DOCUMENTATION TRANSMITTAL

Documentation Description: Nonconformance Reports: C-03719-V  
C-03727-V

NONCONFORMANCE REPORT

16 NCR NO.	C-03727-V	
17 DATE ISSUED	5-12-84	18 REV 0
19	PAGE 1 OF 23 <sup>W/5-12-84</sup>

Ref. FSK-C-113 sht. 18, 19, & 12

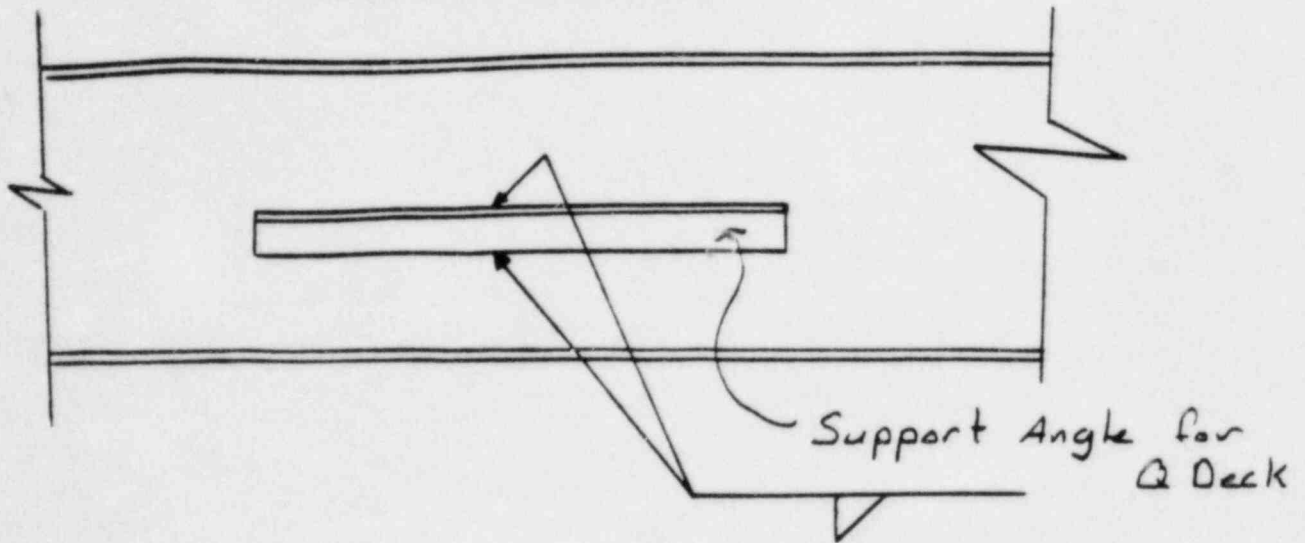
- #54 D11A Bm 20B3R<sup>R</sup> 5'-6"± East of Bm 20B4R<sup>R</sup> Covered with Concrete
- #66, 67, & 68 D11A 12"± 6'± of Bm 21B7R<sup>R</sup> & 21B7R @ G.9 line from Bm 21B5N Embedded in concrete
- #65 D11A All of Bm 21B7R<sup>R</sup> Embedded in Concrete and due to Conduit & Piping Conjestion
- #63 & 64 D11A 12"± 6'± of Bm 21B7R @ G.2 line from Bm 21B5N Embedded in concrete & Conjestion (8'x10's #64 only Pipe Conjestion)
- #53 D11A Bm 20B3R<sup>R</sup> 2'-3"± East of S.6 line Wall covered with Concrete

# 11 #56 Undercut greater than 1/16" deep @ ≈ £ Reactor Bldg. (near unistrut for OVM 15BQ)

#58 Undercut greater than 1/16" deep @ ≈ 2'± S. / £ Reactor Bldg.
